APPLICABILITY: 2015-16MY Legacy and Outback Models
SUBJECT: Design Change to the Fuel Filler Door Assembly

NUMBER: 09-61-15R
DATE: 11/24/15
REVISED: 12/01/15

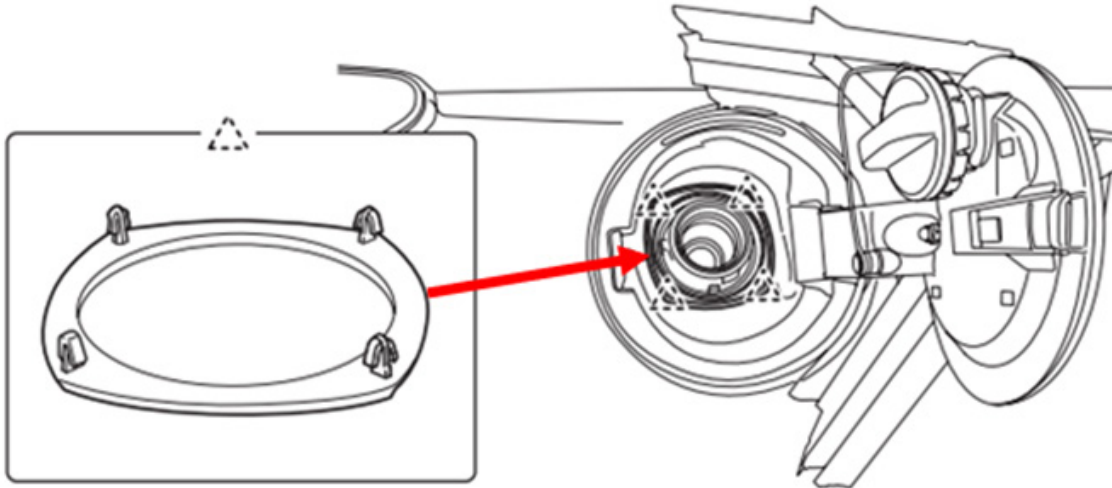
This bulletin announces a design change to the fuel filler door (saucer) assembly to address customer concerns of it being difficult to open and / or close. The striker portion's shape has been changed as shown in the cross-section illustration below along with the type of plastic material used in the construction of the saucer assembly.

If a complaint of the fuel filler door being hard to open or close is confirmed, replace the saucer assembly using the applicable parts listed above following the procedure in the applicable Service Manual.

NOTE: The new plastic lock ring (seal) shown below **must** be replaced also as it is a one-time use part.
